AGENDA
FAYETTE COUNTY PLANNING COMMISSION MEETING
140 STONEWALL AVENUE WEST
November 2, 2017
7:00 pm

PETITION NO. RDP-014-17
Pulte Homes Company, LLC

REVISED DEVELOPMENT PLAN
Brighton
 GEORGIA STATE HIGHWAY 92
 LAND LOTS 1-33-195, 22-227, 5TH DISTRICT
 FAYETTE COUNTY, GEORGIA
 LAST REVISED: 10-23-2017
 DATE: 10-01-2017
 SCALE: 1"=100'
 CN: 1702570P06
 LSV:
 JN:
 FN:
 1 of 1

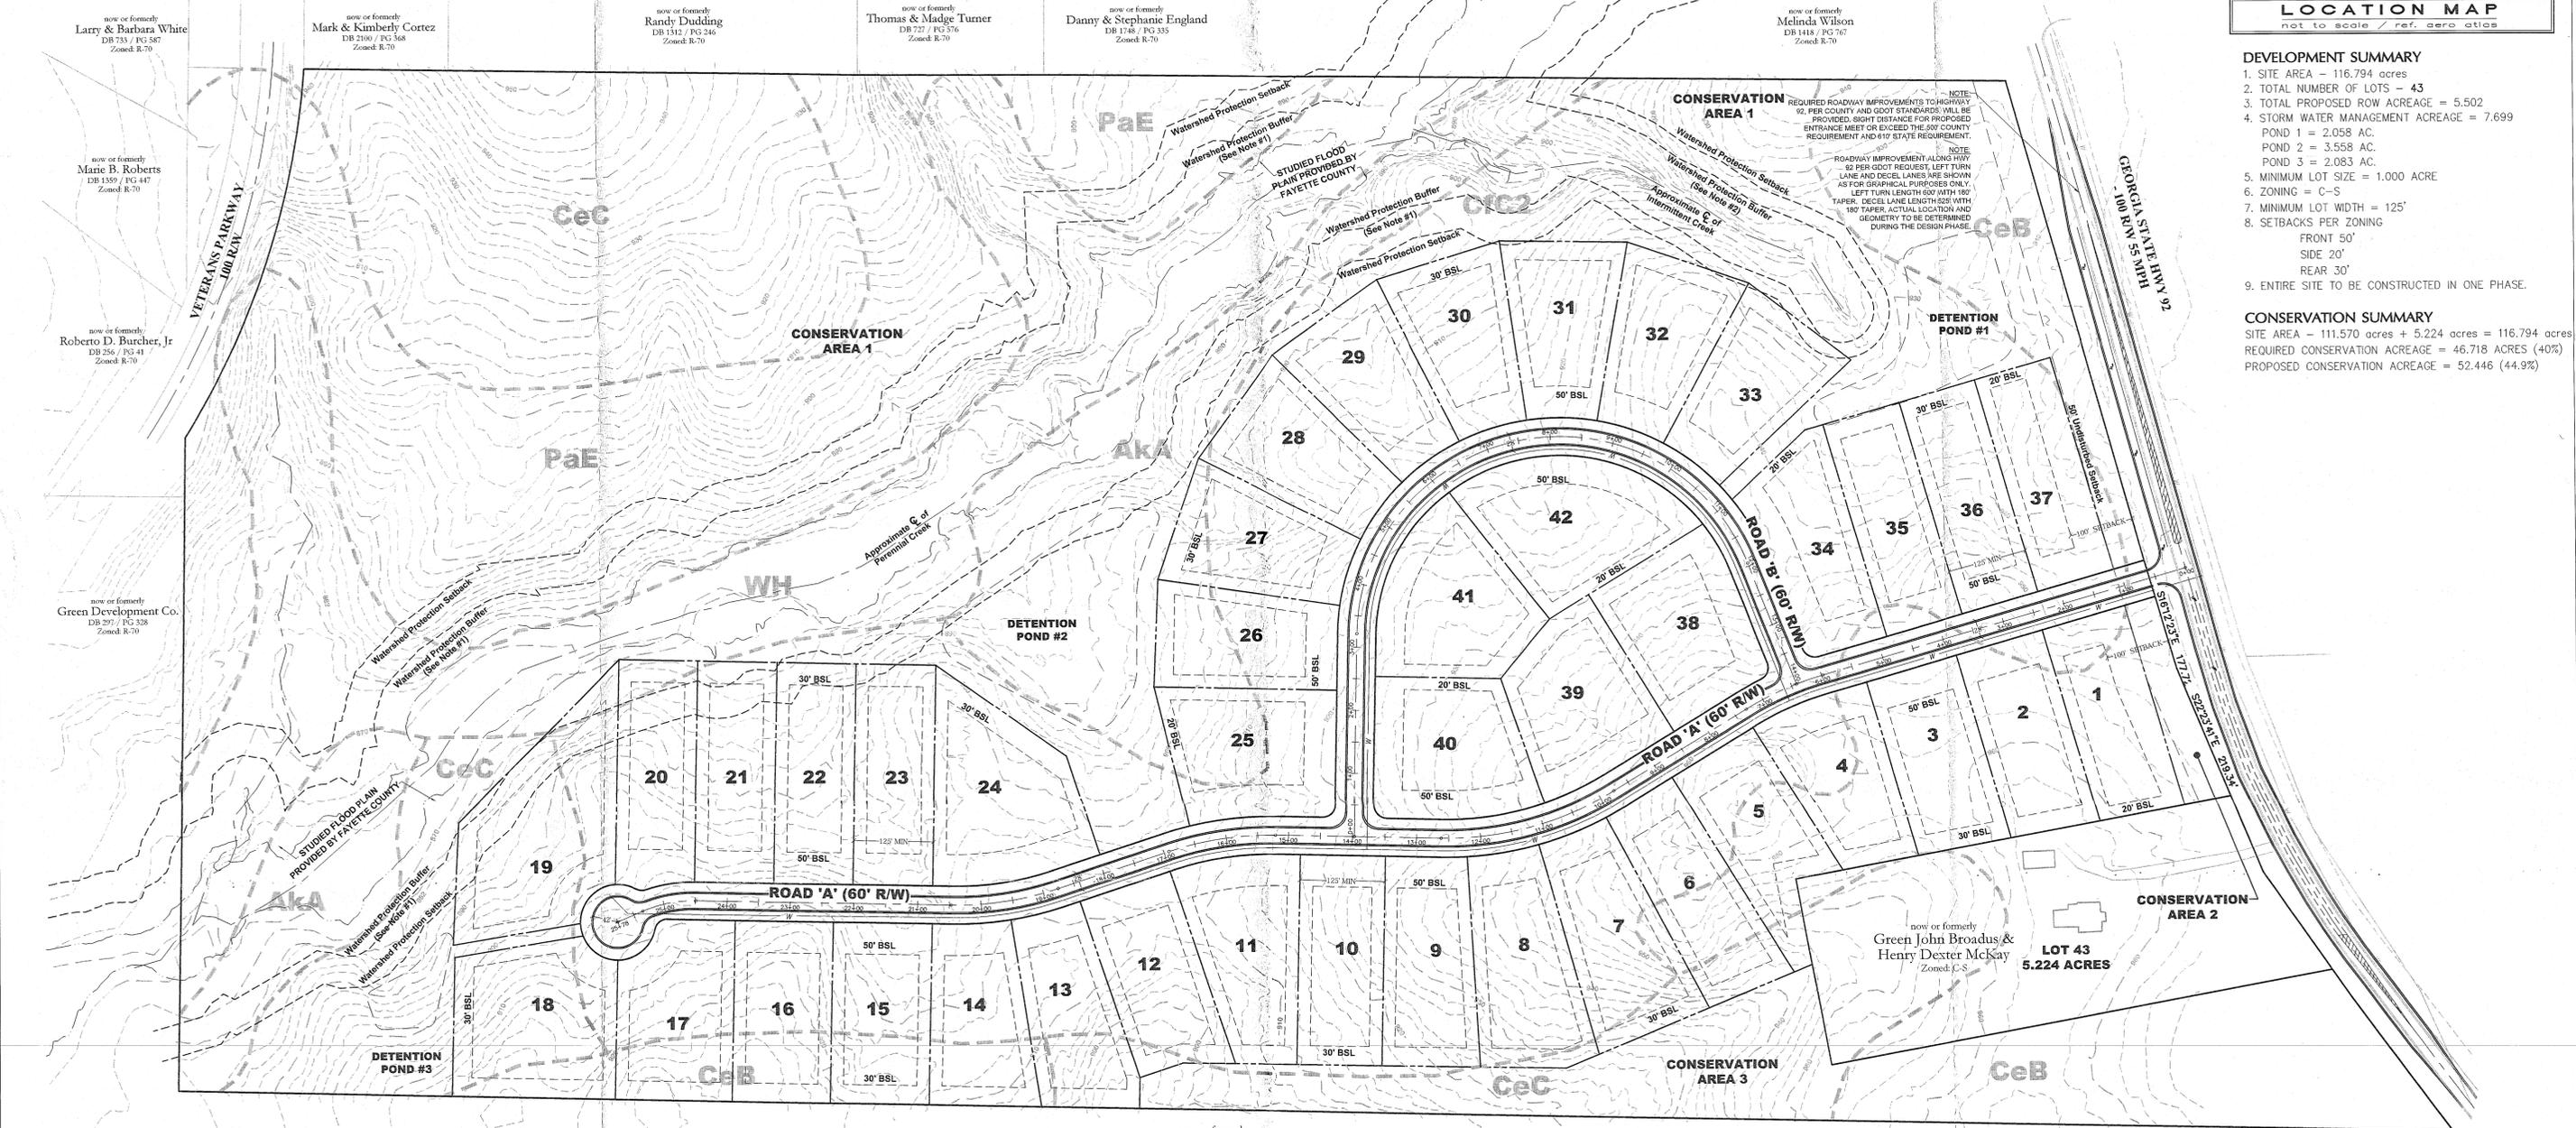
WATER SYSTEM: Need separate utility plan. Submit to FCWS.

FIRE MARSHAL: Must show fire hydrants on preliminary and final plats.

Wetlands Wetlands are not called out on the concept plan. The applicant must call out all wetlands on the preliminary plat and obtain all required permits from the U.S. Army Corps of Engineers prior to issuance of any permits from Fayette County for any phase of development affecting wetlands.

Not approving or denying, but the buffers appear correct but on the preliminary plat, construction drawings and final plat the buffers will need to be shown on the state waters requiring a buffer located within the conservation area.

Stormwater The project is subject to Fayette County's Stormwater Management regulations. Stormwater controls shall be exclusive of the conservation areas. Allow for flexibility along the southern property line of the subdivision (especially near lots 10, 11, and 12). Concentrated flows onto adjacent properties will be prohibited.
